RENESAS TECHNICAL UPDATE

Classification of Production	Development Environment		No	TN-OS*-078A/E	Rev	1.0
THEME	Notes on Use of the Variable-Size Memory Pool Function in the HI8-2600		Classification of Information	1. Spec change 2. Supplement of Documents ③ Limitation of Use 4. Change of Mask 5. Change of Production Line		
PRODUCT NAME	Refer to the following "2. Product Model".	Lot No.	Reference Documents	HI8-2600 User's Manual ADE-702-137A Revision 2.0 HI8-2600 System Configuration Manual ADE-702-138A Revision 2.0		Term of Validity
		V1.0 V2.0WS V2.0 V2.0A V2.0B				Permanent

1.1 Release of a Wait Queue

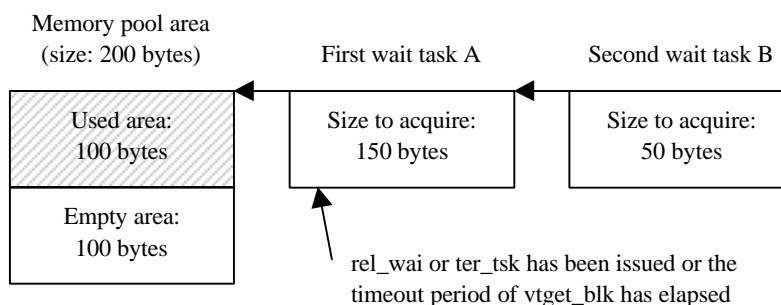
When there are multiple wait queues for a variable-size memory pool, the second and later wait queues may not be released. In this case, tasks in the WAIT state will be released the next time the `vrel_blk` system call is issued.

- (a) There are multiple tasks waiting to acquire a memory block.
- (b) The WAIT state of the first task to acquire a memory block has been released by timeout of `vtget_blk` or system call `rel_wai` or `ter_tsk` (excluding the `vrel_blk` system call).

In the above figure, task A and task B are waiting to acquire 150 bytes and 50 bytes, respectively, of the 200-byte memory pool. When timeout of task A occurs after the specified timeout period of `vtget_blk` has elapsed or the WAIT state of task A has been released by system call `rel_wai` or `ter_tsk` issued to task A, task B still remains in the WAIT state and acquires no memory block even though it has now become the first wait task.

Keep sufficient variable-size memory pool area so that no task will enter the WAIT state.

1.2 Size of a Memory Pool Area

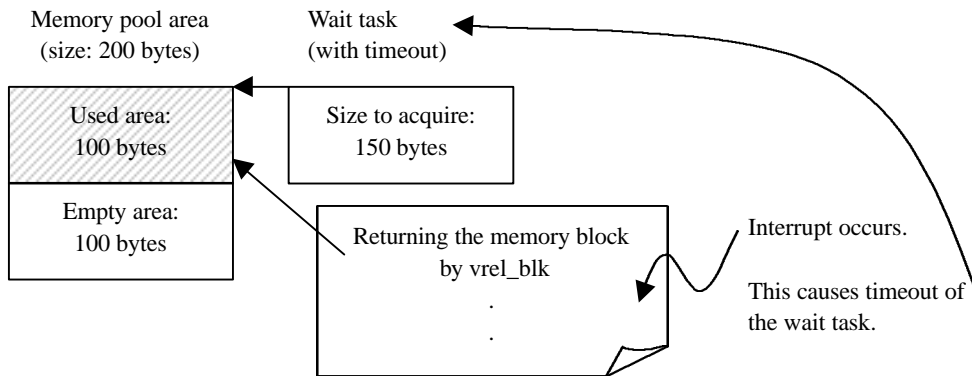
The available size of a variable-size memory pool may be reduced.

- (a) There is a task waiting to acquire a memory block.
- (b) The WAIT state of the first wait task is released while the memory block is being returned.

In the above figure, there is a wait task with timeout for the memory pool. When a timer interrupt occurs and causes timeout as the timeout period remained for the wait task is zero while the memory block is being returned by vrel_blk, 150 bytes of the memory pool area will be used and thus the empty area will be 50 bytes. The wait task has already had timeout and acquired no memory block. However, the memory pool assumes that the memory block is acquired.

Keep sufficient variable-size memory pool area so that no task will enter the WAIT state.
